Houston Heights Historic Districts Design Guidelines

Recommendations resulting from Public Hearing comments.

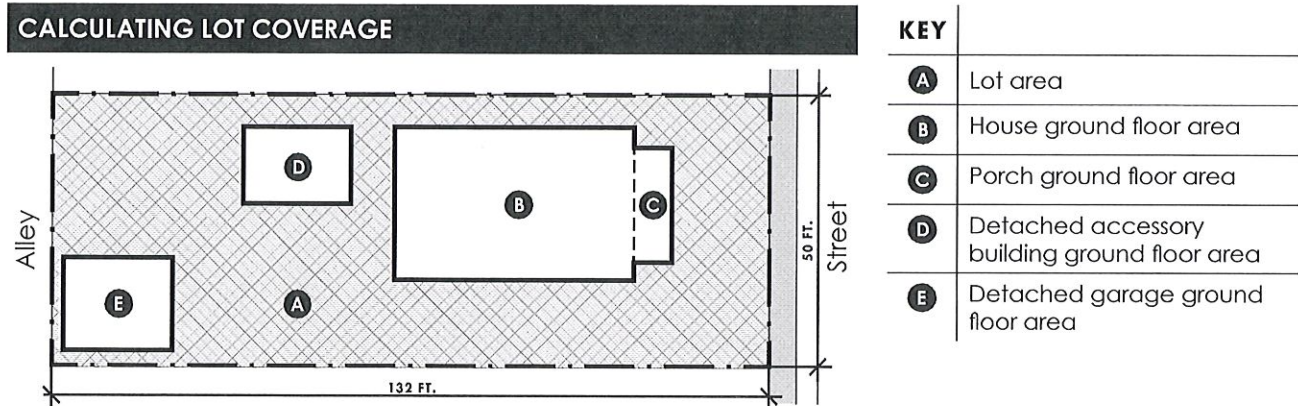
Comment #2:

Change the window replacement criteria.

Remove the formula and continue to review window replacement on a case-by-case basis.

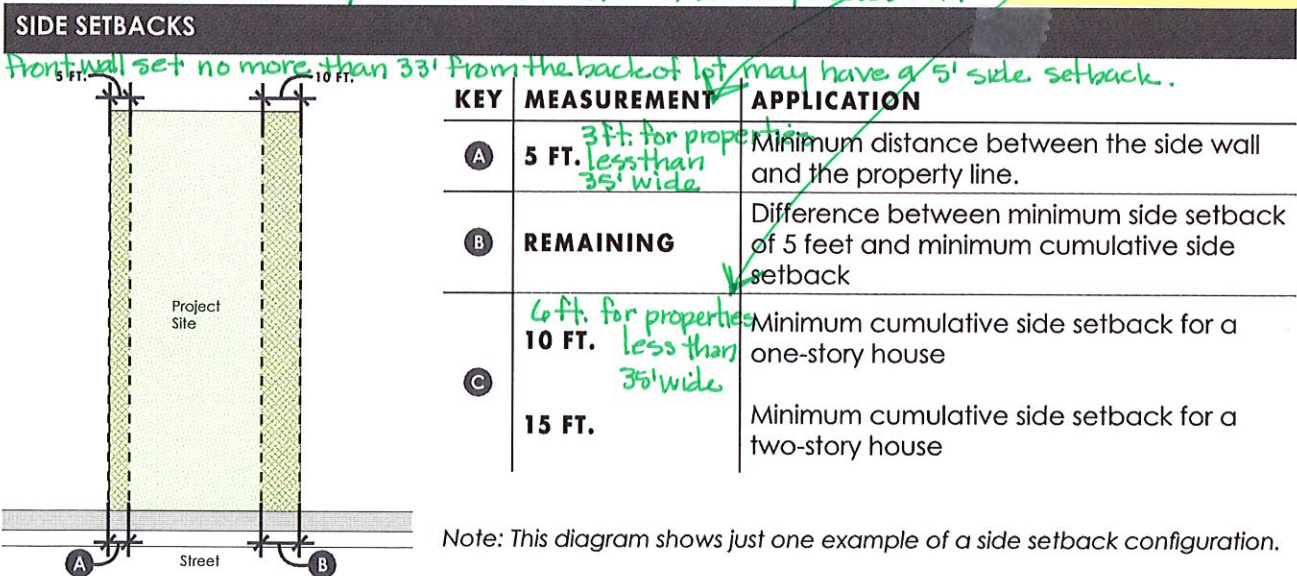
Comment #9:
Allow garages to have lesser setbacks

Comment #7:
reduce setbacks for smaller properties.
HATC decision:
Allow 3' side setbacks for properties less than 35' wide

HATC decision:
see below

PRIMARY BUILDING WALL PLATE HEIGHT

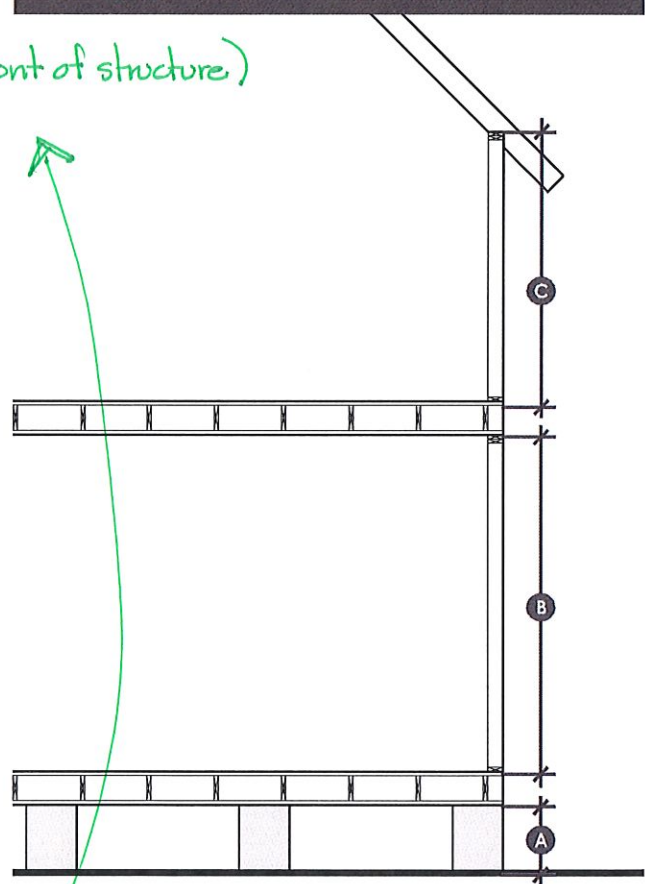
14		<ul style="list-style-type: none"> Correct drawing p. 5-16 for maximum finished floor height A 	The dimension labeled A represents the height of the pier, not the finished floor.	Correct the drawing.	No vote required.

Comment #5:
Increase plate height

Comment #16:
Increase finish floor height to 36"

- Maintain existing plate heights for first and second floors
- Remove language suggesting a specific interior act. Beyond scope of historic preservation office

- Increase finish floor height to 36"
- Add language that measurement is taken at front of structure.
